Planning Commission

Planning Commission Meeting Agenda
Hartland Town Hall
Thursday, October 08, 2026
7:00 PM

Subject: Site Plan Application #26-011 Proposed facade and site renovations at 10440 Highland Road

10440 Highland Rd.
Hartland, Michigan

ELEVATION - NORTH WITH CANOPY
SCALE: 1/8" = 1'-0"

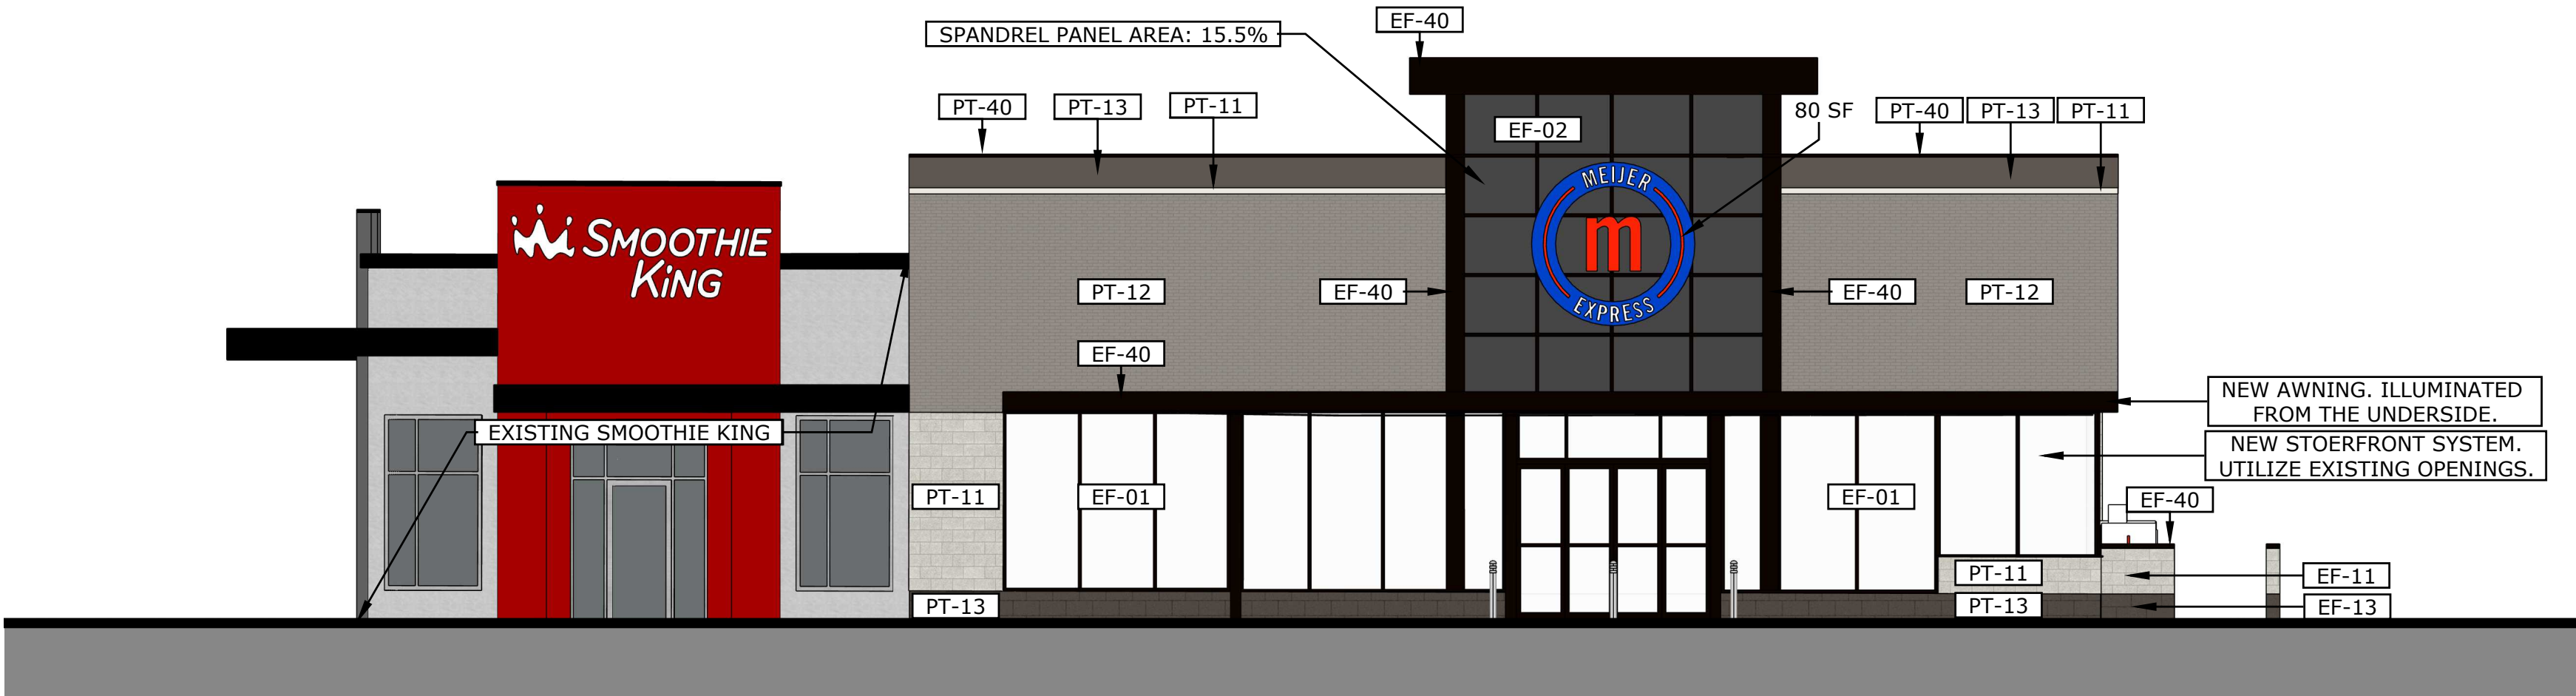
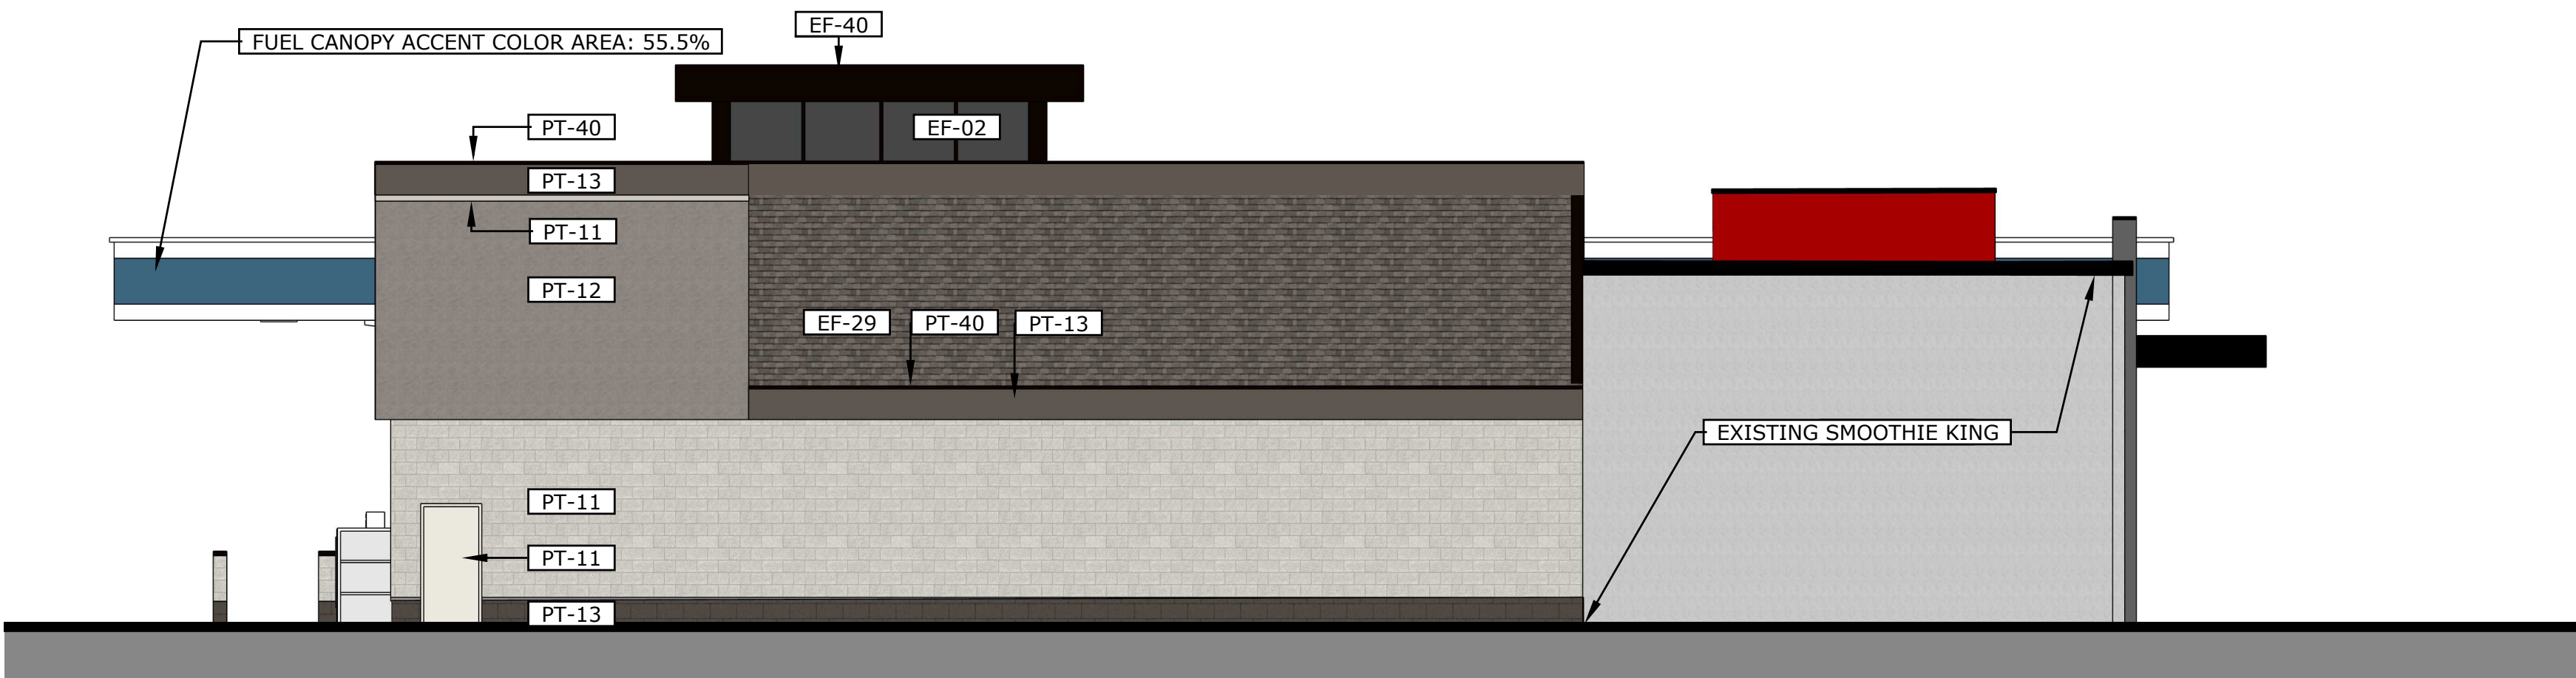
3. Signs are not approved as part of this request. The blue accent stripe on each of the four (4) sides of the fueling station canopy is not approved as part of this request. Signs and the blue accent stripes require separate sign permits which are subject to an administrative review by the Planning staff.

The existing feature element on the north elevation, over the entrance doors, will be replaced or covered with a tinted spandrel panel system with a grid pattern (labeled as faux tower on the architectural plans). The panel system is dark bronze in color with matching metal trim accents. The proposed panel system with trim on top cap extends approximately five (5) feet above the top of the parapet wall. The total height of the building is 23'-10" from the ground to the top of the trim cap on the proposed panel system.

Regarding the canopy: If you would allow, Meijer would like to leave the canopy drawings as they were submitted. They feel that their prototypical canopy face with the blue band is important for their branding and would like an opportunity to discuss it further at the Planning Commission meeting.

ELEVATION - WEST
SCALE: 1/8" = 1'-0"

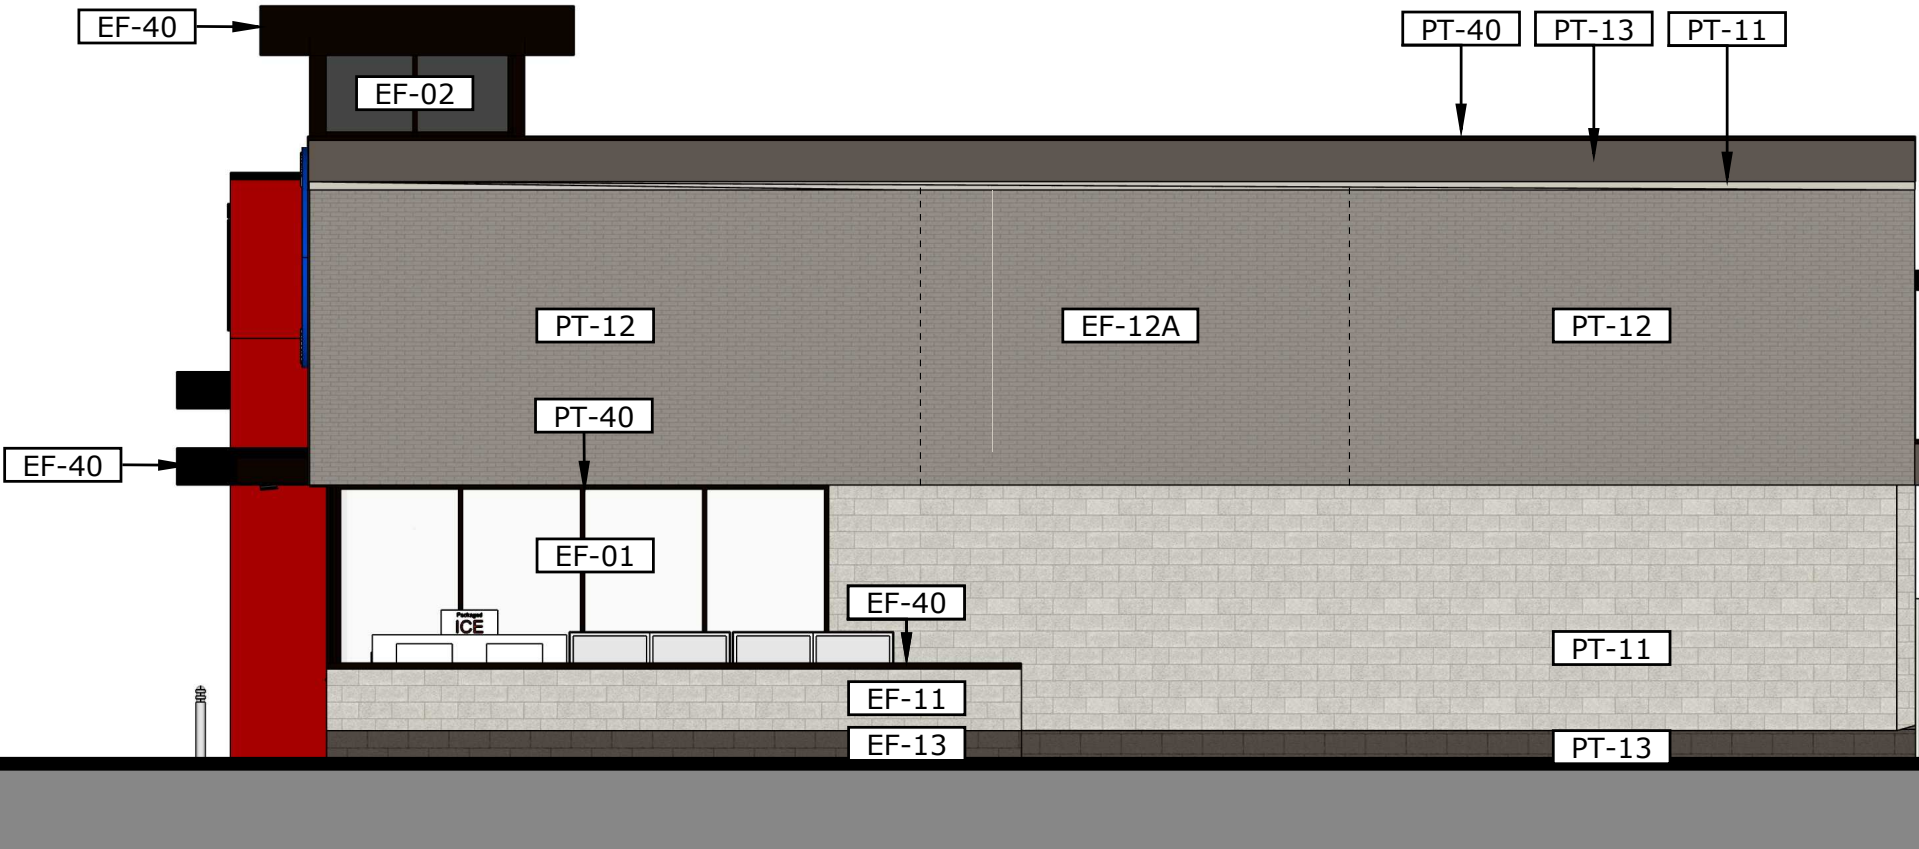
A new screen wall is proposed at the west end of the north (front) elevation. The screen wall is comprised of split face block as the base and topped with brick, both of which will be painted to match the building's colors. The overall wall height is 4'-6". The intent is to provide a dedicated area for outdoor storage along the west side of the building. A new ten (10) foot wide sidewalk is also proposed along the length of the west elevation.

The plans show a proposed outdoor storage area on the west side of the building. This area is screened by a masonry screen wall at the northwest edge of the building. The wall is comprised of a CMU/block base and topped with brick, painted in two (2) tones of grey to match the north elevation colors and design. The overall screen wall height is 4'-6".
